SERVICE BULLETIN

ENGINE — LP COMPRESSOR — PROVIDE A NEW FAN CASE TO MAIN
GEARBOX ASSEMBLY MATING SEAL RING

V2500 Series 72-0662

V2500-ENG-72-0662

LOCATION OF SEALING RING
72-32-00
FIGURE 1

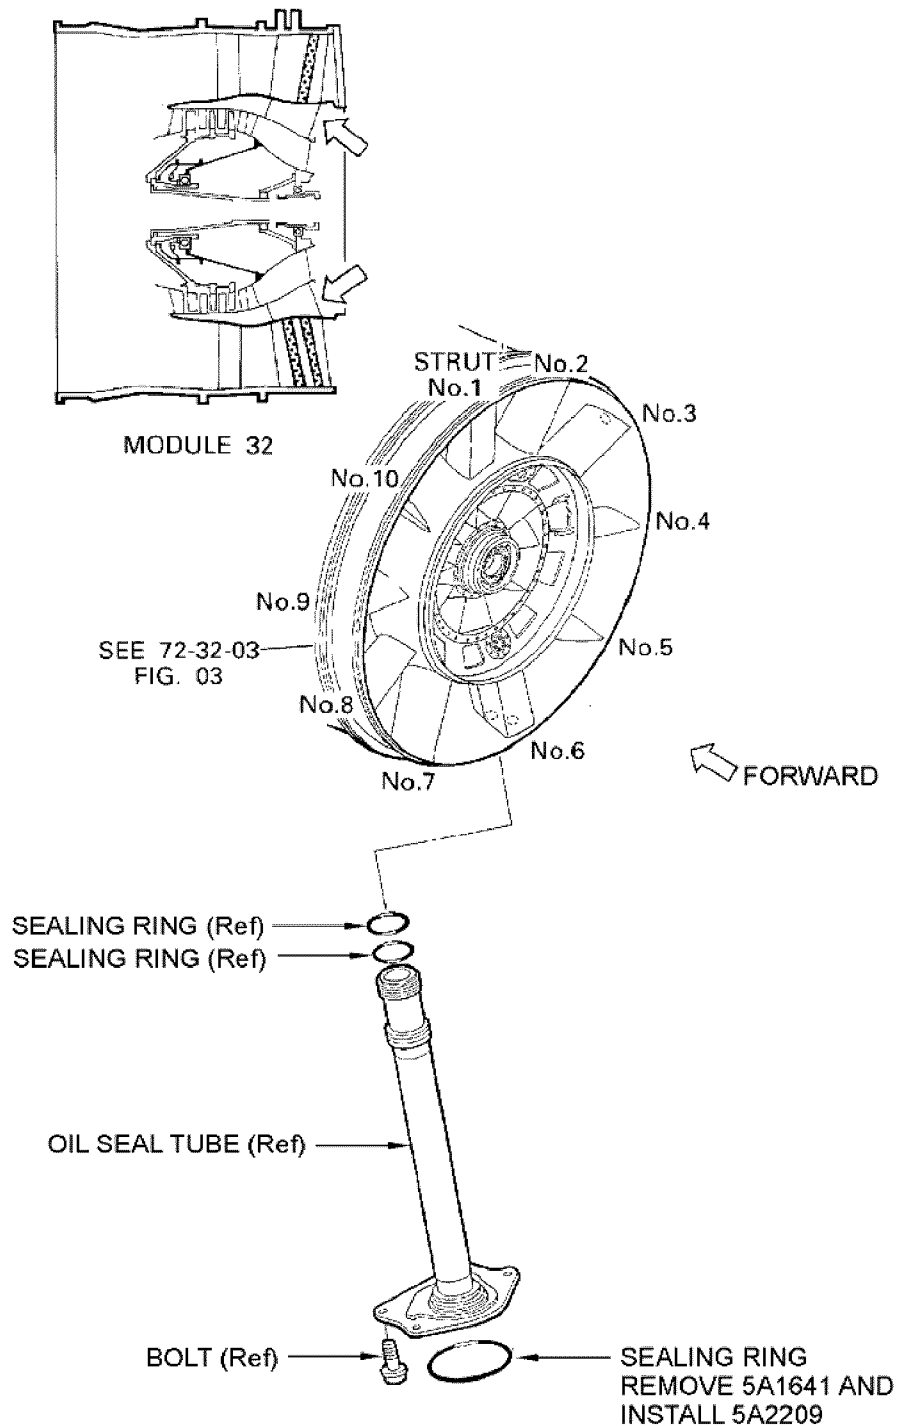
The material of seal ring on the oil seal tube is changed to improve the compatibility with HTS oil.

1. Install the Sealing Ring, PN 5A2209 in accordance with References 5 and 6, Engine Manual, Chapter/Section 72-32-00 Assembly-011 or 72-00-60 Installation-001/Installation-002. See Figure 1.
2. Recording Instructions
 - A. A record of accomplishment is required.
